Access Compliance Report

Public Rights-of-Way

(Curb Ramps)

Intersection ID: 53233	Main Street: FLEETWOOD_DR	Cross Street: HORNETS_NEST_WY	Location: SW
ADA ID: 606AC482B4E9	Ramp Type: BlendTrans1	Initial Pass/Fail: Fail	Overall Compliance: No
		Severity Score: 10

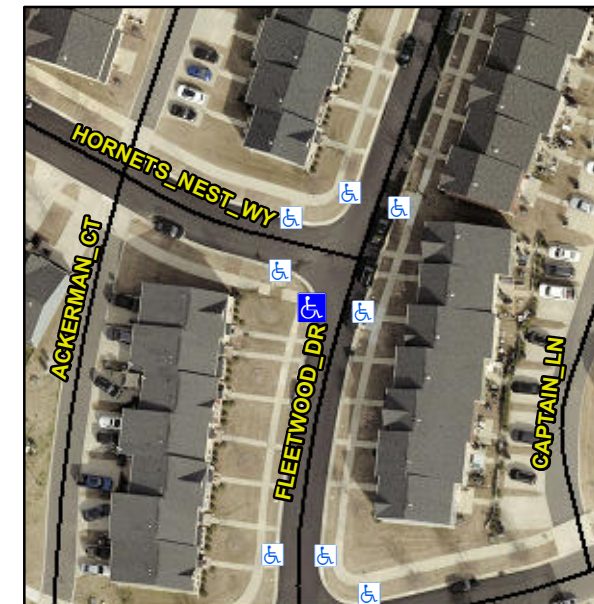
Remove & Replace Curb Ramp With Two New Directional Ramps or Equivalent.

R304.5.1
